SUBJECT: COMANCHE PEAK STEAM ELECTRIC STATION (CPSES)
DOCKET NOS. 50-445 AND 50-446
REQUEST FOR ADDITIONAL INFORMATION REGARDING
LICENSE AMENDMENT REQUEST (LAR) 01-012
STEAM GENERATOR TUBE REPAIR USING LEAK TIGHT
SLEEVES

Response to NRC Questions Concerning Hydraulic Equivalency for Leak-Tight Sleeves

Figure 3-1 Ratios of Hydraulic Equivalencies Based on the Test Data to SLEEVE Code Predictions

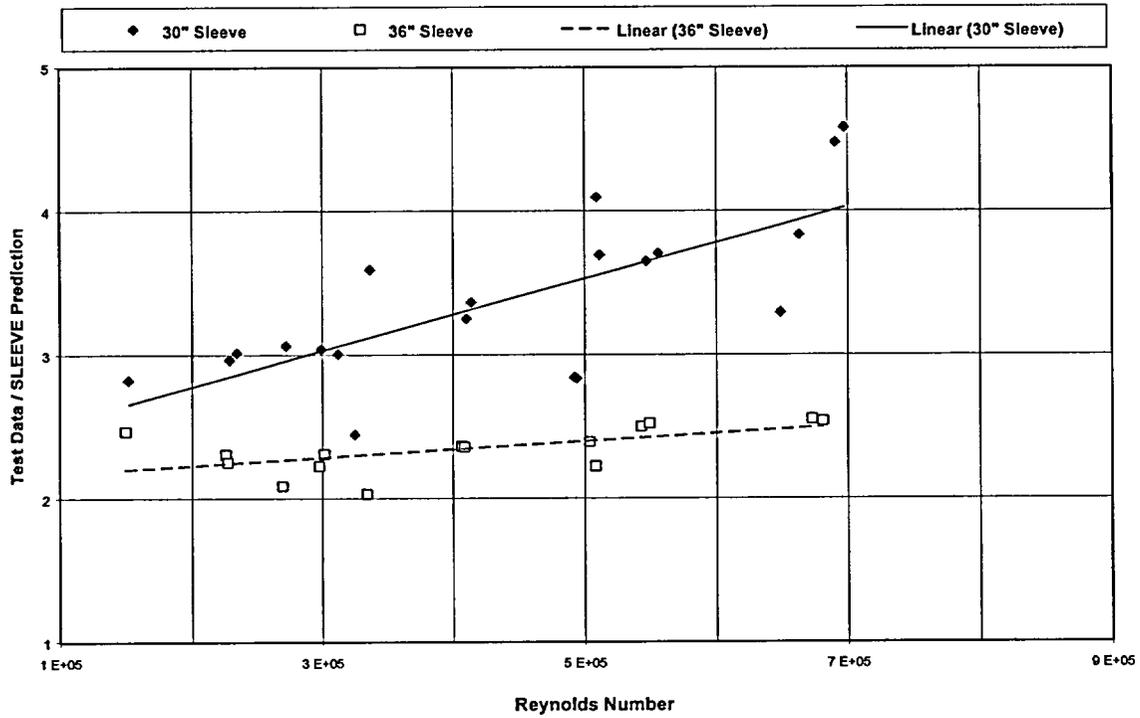
3. We do not recall any mention of an expansion/contraction multiplier to account for transitions that were gradual as opposed to sharp in the laser modeling. Were such multipliers used? If so, what values were used? The same observation and question applies to the test configuration. How do the coefficients compare with those from a traditional reference such as Crane Technical Paper 410?

As shown, the ratios of the hydraulic equivalency numbers range only from 1.3 to 1.5. It is apparent that use of sudden transitions to replace the actual gradual transitions doesn't account for the total conservatism of 2 to 4 times, as demonstrated by test results (see Figure 3-1). In other words, it seems to indicate that there are still other conservatisms in the calculation by the Westinghouse SLEEVE Code.

Both the laser sleeves and the test configuration evaluated the sudden transitions, not the gradual ones. Therefore, no multipliers were used in both situations. Thus, their comparison with the Crane Paper 410 is similar to the table shown in response to question 1 for the sudden contraction. As for the sudden expansion, they are exactly identical to the Crane Paper 410, because they all use the same correlation (see Equation (2-5) shown in response to question 2).

As for the actual configuration of the laser sleeves and its test configuration, both had had the transition as a gradual expansion or a gradual contraction. Therefore, it is

conservative to use a sudden contraction or sudden expansion for both the laser sleeves and its test configuration in calculating the hydraulic equivalency. As demonstrated from comparison between the calculations and tests, the conservatism is at least amounted to a factor of 2; in fact, could be as high as 4 (see Figure 3-1).
